(Z)2263  
1 July 2021

## Analysis of Elia's Adequacy and Flexibility study for Belgium 2022-2032

drawn up pursuant to article 23, § 2, second paragraph, 2° and 19°,  
of the law of 29 April 1999 on the organisation of the electricity  
market

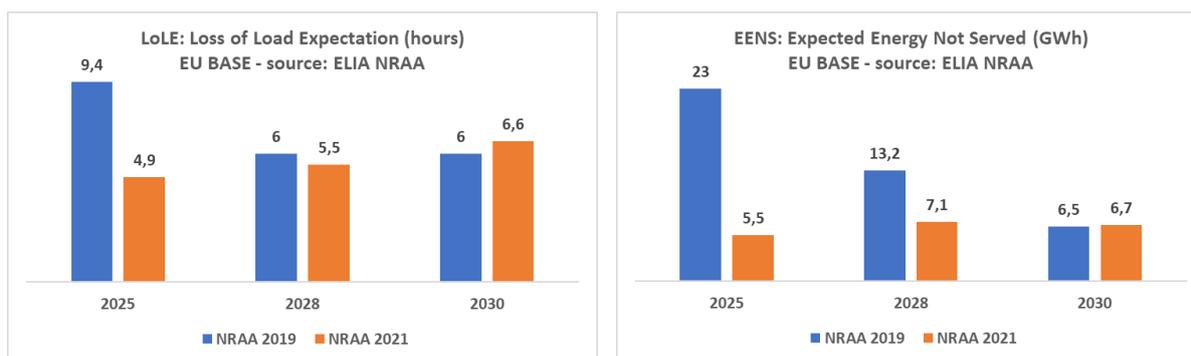
5. The results show a strong decrease of the adequacy concerns in Elia's study from 2021 compared to the 2019 study. This is illustrated in the figures below. These results are obtained in the absence of intervention (so without a capacity mechanism).

6. The **LoLE** in 2025 is estimated at 4,9 hours on average in the 2021 adequacy study, about half of the LoLE in 2019 (9,4 hours). Subsequently, in 2028, the estimated LoLE increases only slightly to 5,5 hours in the NRAA 2021, which is still lower than what was estimated in 2019 for this year.

7. The decrease in **EENS** is even more spectacular. Elia's 2021 adequacy study estimates a EENS of 5,5 GWh for 2025, whereas the NRAA 2019 estimated 23 GWh, or more than four times more. For 2028, the EENS increases to 7,1 GWh in the 2021 study, but still about half of what was estimated in 2019 for this year.

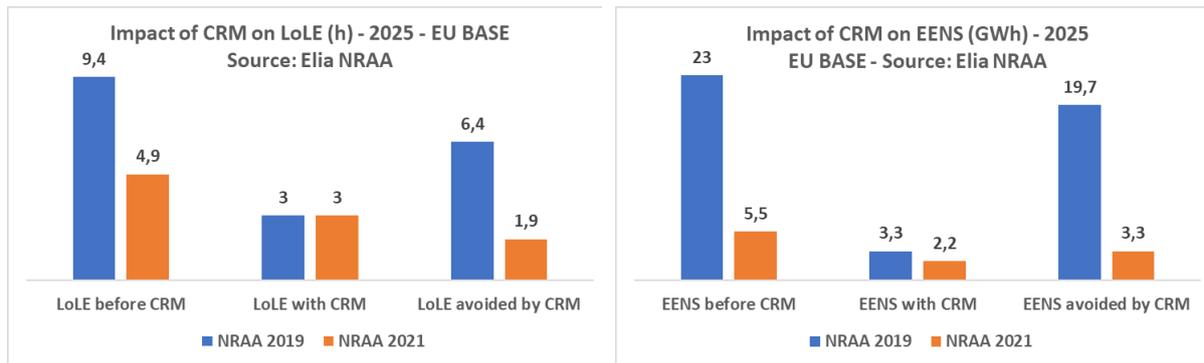
9. The figures below show the impact of a CRM on the LoLE and EENS. In Elia's study from 2019, the LoLE decreased from 9,4 hours on average to 3 hours on average, or a decrease of 6,4 hours. However, in Elia's study from this year, the LoLE decreases from 4,9 hours to 3 hours, or a decrease of 1,9 hours on average. Compared to the 2019 study, the Elia study from 2021 shows that introducing a CRM has an impact on LoLE that is more than three times less.

10. The effect of a CRM on EENS is even much lower. In 2019, Elia estimated that the EENS would decrease from 23 GWh to 3,3 GWh, meaning that introducing a CRM would avoid curtailment of 19,7 GWh. In this year's adequacy study, Elia estimates that the EENS would decrease from 5,5 GWh to 2,2 GWh, or a decrease of 3,3 GWh, meaning that a CRM avoids 3,3 GWh of curtailment. The impact of a CRM on EENS has decreased with a factor of six.

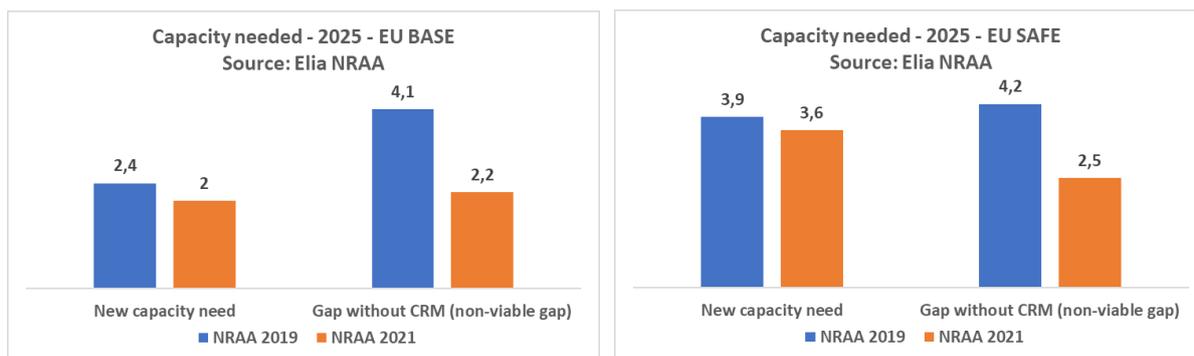
15. The figures below show the new needed capacity for Elia’s EU-BASE and EU-SAFE scenarios for 2025 (left columns), as well as the capacity that is missing when no CRM is introduced (right columns).

16. From these figures it is clear that the missing capacity, when no CRM is introduced, has almost halved compared to Elia’s adequacy study from 2019. In the EU-SAFE scenario, 2,5 GW are missing (in 2019, this figure was 4,2 GW) while in the EU-BASE scenario, 2,2 GW are missing for 2025 (against 4,1 GW in 2019).
